**Realistic loss-of-coolant accident (LOCA) Evaluation Methodology
Applied to the Full Spectrum of Break Sizes
(FULL SPECTRUM™ LOCA Methodology)**

WCAP-16996-P/ WCAP-16996-NP Volumes I, II and III, Revision 0, “Realistic loss-off-coolant accident [LOCA] Evaluation Methodology Applied to the Full Spectrum of Break sizes (FULL SPECTRUM™ LOCA Methodology)”

REQUEST FOR ADDITIONAL INFORMATION (RAI)

FIRST SET OF RAI QUESTIONS

Figure: Illustration of PCT Response to Break Size Variation for Appendix K SBLOCA Analysis

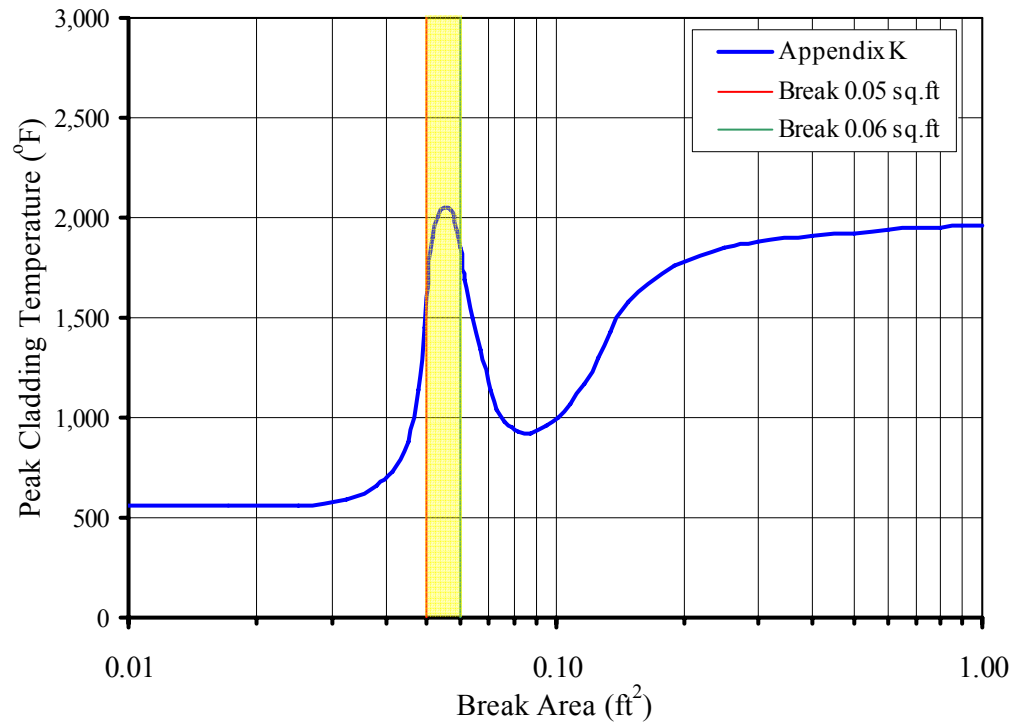
] Please present the updated Figures 31.3-4 to 31.3-7 and Tables 31.3-1a and 31.3 1b to illustrate the obtained results. If this approach does not guarantee adequate resolution of the worst break, please consider an alternative method as discussed in the following paragraph. Please be aware that for some plants the PCT can increase by a few hundred degrees Fahrenheit when the break size changes from 0.05 ft^2 to 0.06 ft^2 . Thus, it has been shown for some plants that the PCT can increase by approximately 100°F for a small break area increase of 0.005 ft^2 so that the 0.055 ft^2 break PCT is higher than both the 0.05 ft^2 and 0.06 ft^2 break. This limiting break is characterized by RCS pressure that just depressurizes to a pressure within several psi of the safety injection tank (SIT) actuation pressure. Because such behavior characterizes most plants, it is necessary to resolve the size of the worst break

controlled entirely by the HPSI injection only. While this low range of small break sizes is most pronounced under Appendix K analysis assumptions, it still needs to be evaluated in the best estimate space since future increased power levels and linear heat generation limits will also produce such a temperature spike for such a small break window. The included figure illustrates the described PCT behavior. In addition, sometimes this worst break size can be just slightly larger than that at which SIT injection is prevented. In this case, a small amount of injection after a deeper core uncover can often lead to the worst break because SIT injection quickly terminates with only a small increase in core level as the RCS pressure can quickly increase with the small level change.

To assess the appropriateness of the proposed position in the FSLOCA methodology regarding SBLOCA resolution and treating the worst break size in Region I, please present the results from an additional analysis for the three-loop Westinghouse plant examined in Section 31.3. In this analysis, please assume that Region I breaks range from 2.0-inch to 6.0-inch equivalent diameter (0.022 ft^2 to 0.196 ft^2 or 0.5 percent to 4.8 percent break area) and vary the break in increments of 0.2 inch. Please perform the analysis assuming nominal values for all remaining sampled parameters including the break discharge coefficients. In addition, show the effect of key parameter variations from the nominal values over this detailed range and present the updated Figures 31.3-4 to 31.3-7 and Tables 31.3-1a and 31.3-1b using the obtained results.
